**GEOLOGIC AND GEOTECHNICAL ASSESSMENT
RFETS BUILDING 371, ROCKY FLATS, COLORADO (U)**

**WSRC-TR-95-0482
Revision 0**

Reviewed by: L. A. Salomone
SRS Chief Geotechnical Engineer

Figure 16
Stratigraphic & Structure Correlation Panel

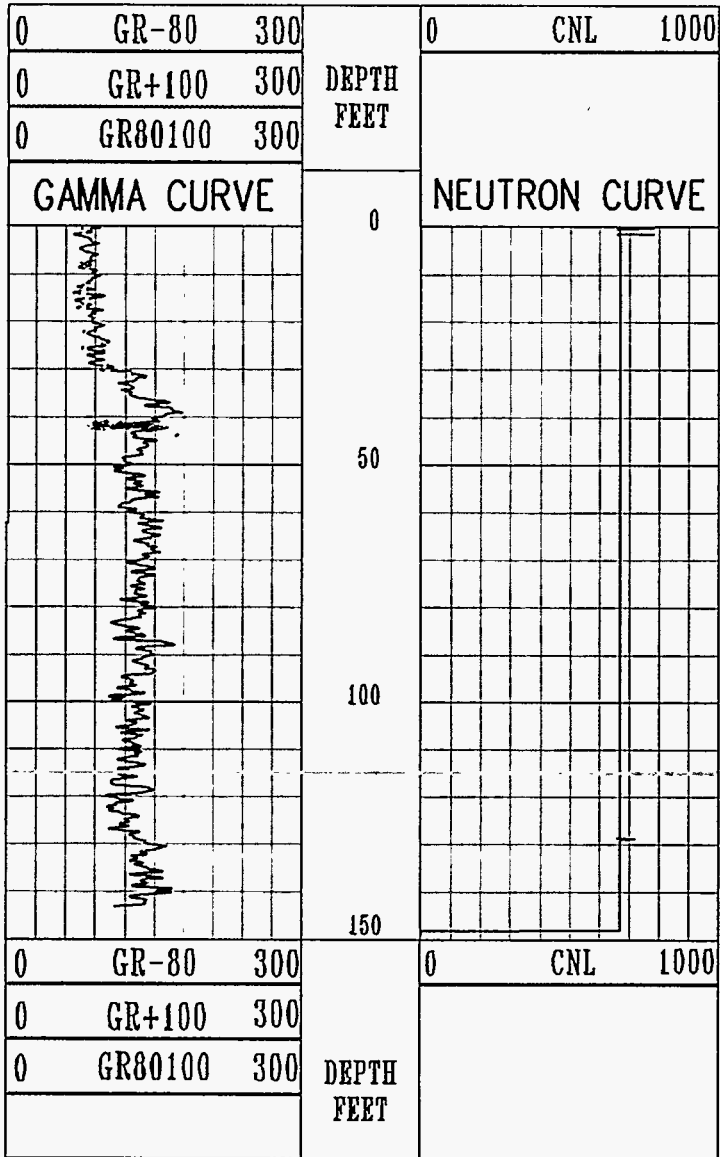
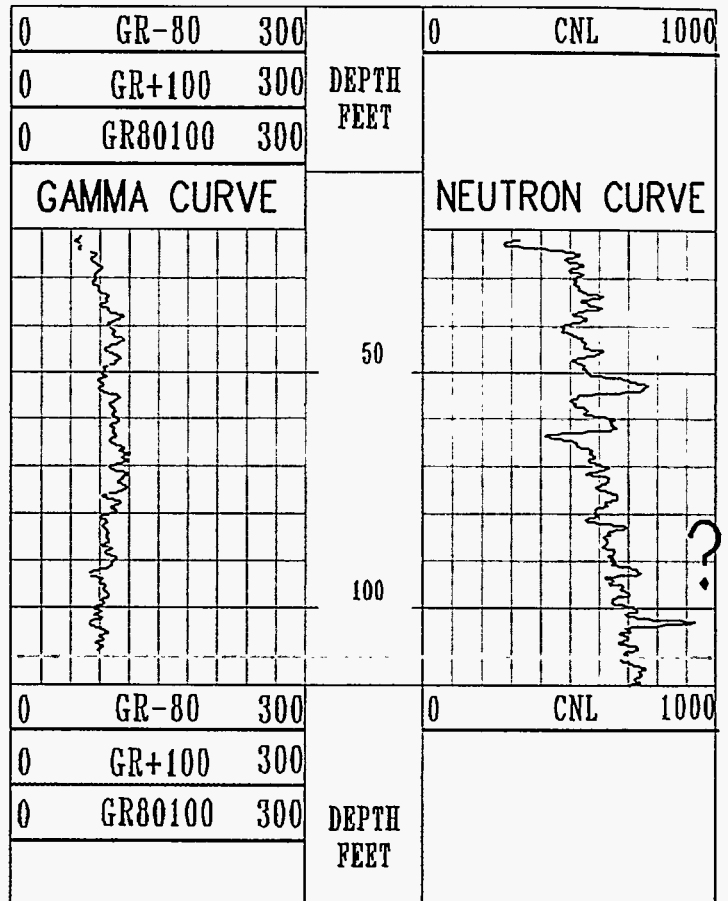
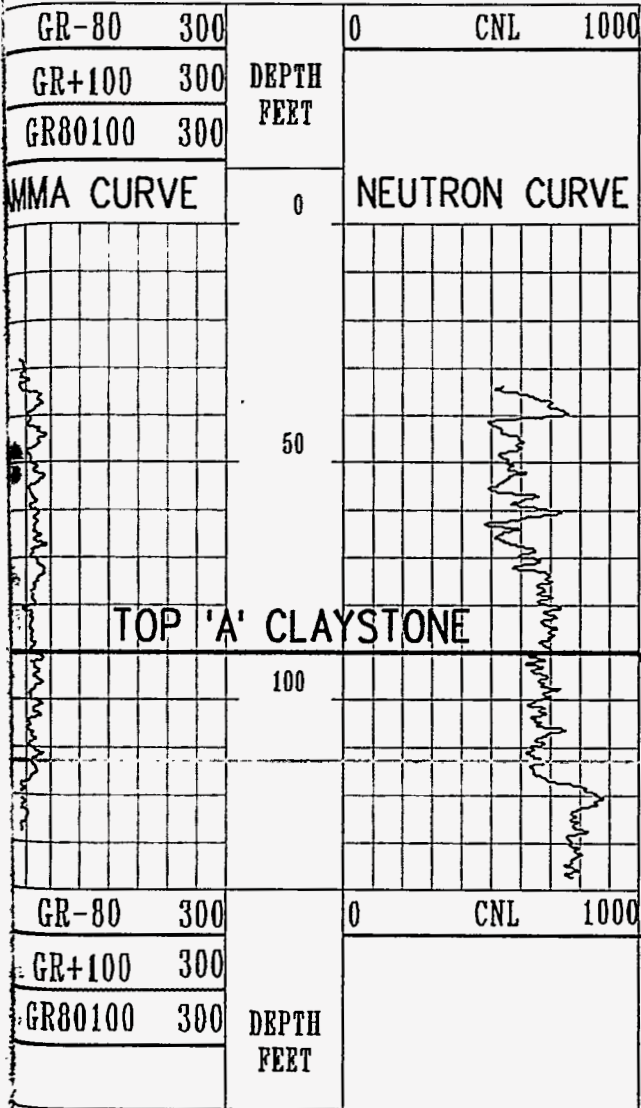
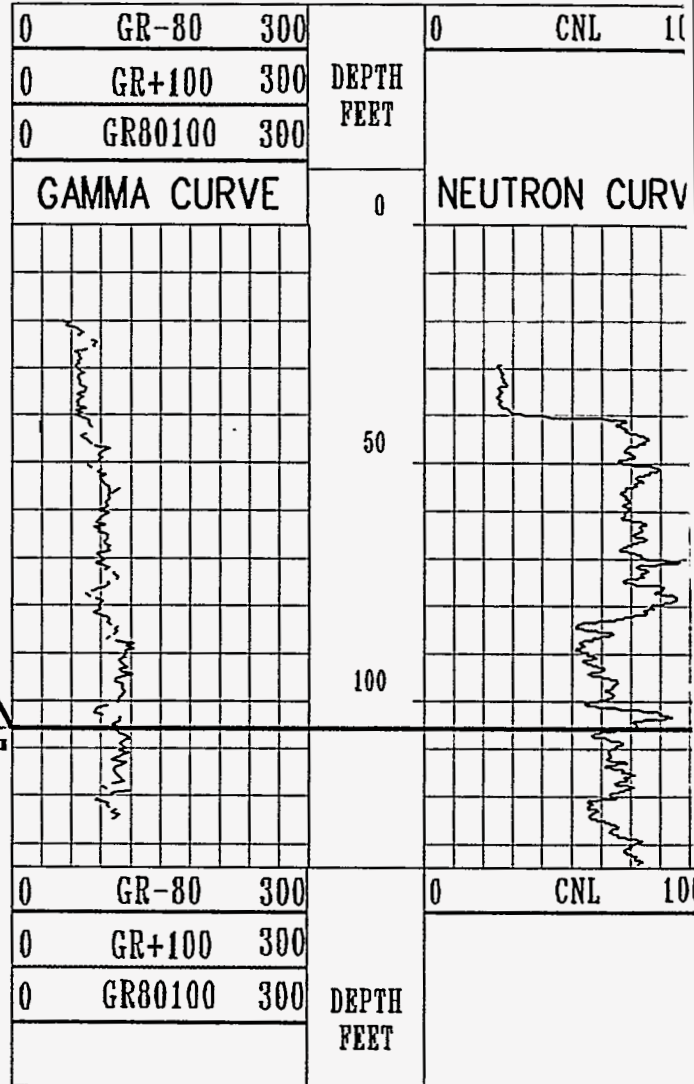
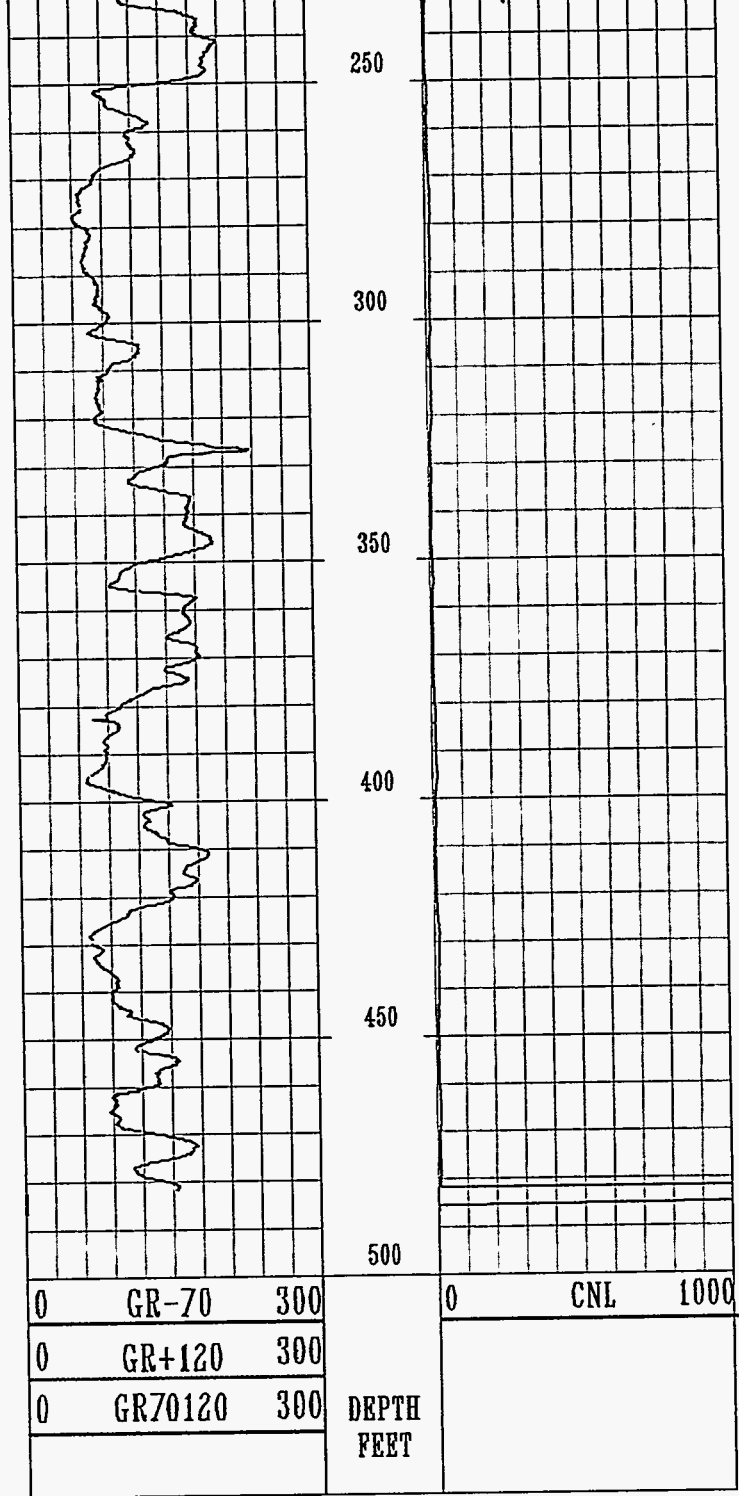
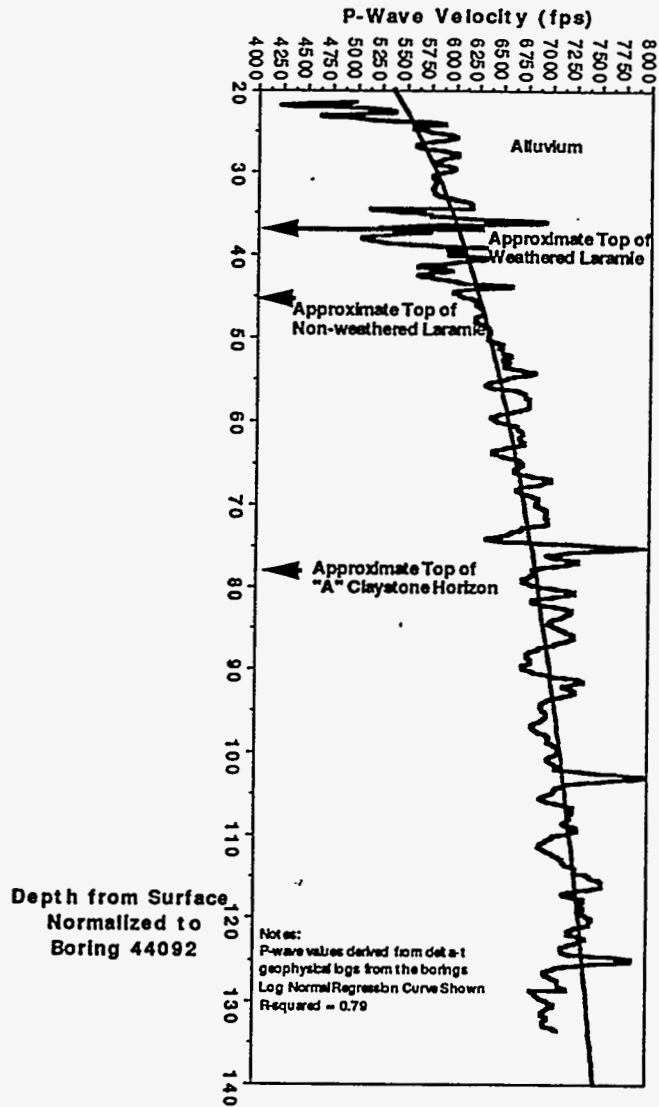
A review of Figure 16, the correlation panel, quickly demonstrates two issues involved in the understanding of the geology under Building 371. First, the high lateral and vertical variability of the subsurface sediments makes correlation difficult, if not impossible. The nature of the deltaic depositional system in the upper portion of the Laramie Formation implies that numerous clays, silts and fine grained sand may be deposited in near proximity causing a high lateral variability. These materials will also weather differently enhancing the variability. Vertical variability is caused by the migrating nature of deltaic deposition where thin laterally variable units are deposited in a stacked configuration. Also, by definition, alluvial deposits are variable. The field sample descriptions from auger borings through the Rocky Flats alluvium (prior to sitting surface casing) confirms a wide range of alluvial sediment types underlying Building 371.

Secondly, because of the lithology variability, correlation of more than the interpreted "A" claystone (derived from core descriptions and interpolated across the panel) is not possible using shallow borings and the determination of three dimensional geologic structure or the modeling of geological features is precluded. The lithology of the Laramie Formation is consistently variable (there are no definitive marker horizons), therefore log correlations and mapping is based on a best-guess approach. In order to determine the geometry of the Laramie, i. e., the dip of the beds, it is necessary to define a defensible marker horizon, which probably is the Fox Hills Sandstone Formation or the Pierre Shale. It is possible to use shallow data from some of the borings to verify existing interpretations. The change in the elevation of the "A" claystone is consistent along strike (from borings 1493 to 43792) and then changes abruptly from boring 43792 to boring 44192, suggesting the presence of fault #2. The change in the elevation of the "A" claystone from boring 44192 to boring 43992 may be caused by a change in dip or by the near presence of inferred fault 2a as described in the Geological Characterization Report, dated March, 1995.

Figure 18
Blackhawk Hole-J Descending P- & S-Wave Data Versus Averaged P-Wave Curve

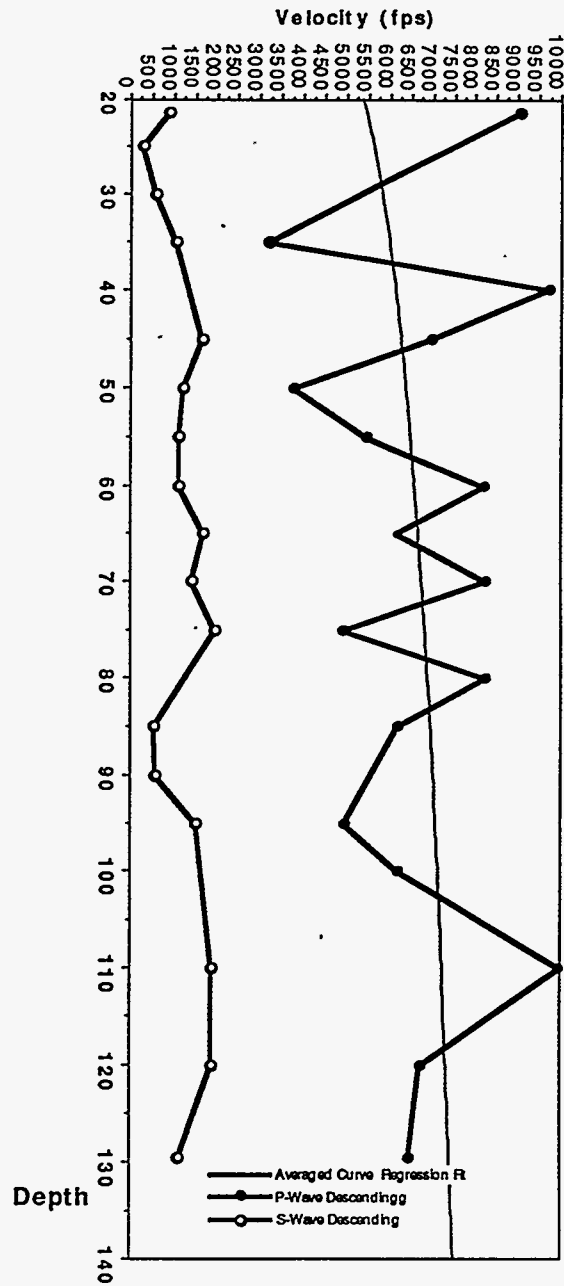
Figures 8 and 18 compares the averaged curve from boreholes 44092, 43992 and 44192 with the P-wave curves determined from the Blackhawk data for Hole J (boring 1293, nearest Building 371) in ascending and descending mode, respectively. It is apparent from these graphs that many of the Blackhawk ascending and descending results do not correlate, nor correlate with the averaged curve. In only two cases, 35 feet and 110 feet, do the Blackhawk ascending and descending results agree, and in only seven measurements do the results fall within approximate proximity to the averaged curve. As compared to the averaged curve only 9 of the 20 total measurements are potentially significant. The log normal linear regression curve for the velocity values for the Blackhawk ascending data consistently vary between 800 to 1000 fps as compared to the averaged curve. The averaged Blackhawk descending data show velocity inversion with values at the surface approximately 1000 fps faster than values at depth. Reviewing Figures 8 & 18 suggests that the ascending and descending Blackhawk survey S-wave velocities from Hole J vary by 500 to 700 fps with some disagreements as large as 2500 fps. Differences in ascending and descending values may be explained by a differing orientation of the receiving shuttle or by an inadequate clamping of the receiver to the boring wall. The reasons for the differences in velocities between the Blackhawk data and the geophysical log data are probably caused by the difference in acquisition technique. The Blackhawk data were acquired over a larger volume of lithology which averages inherent subsurface velocity differences. Because of this, it is difficult to determine where, within the volume of lithology evaluated, velocity contrasts occur. Additionally, Blackhawk data were
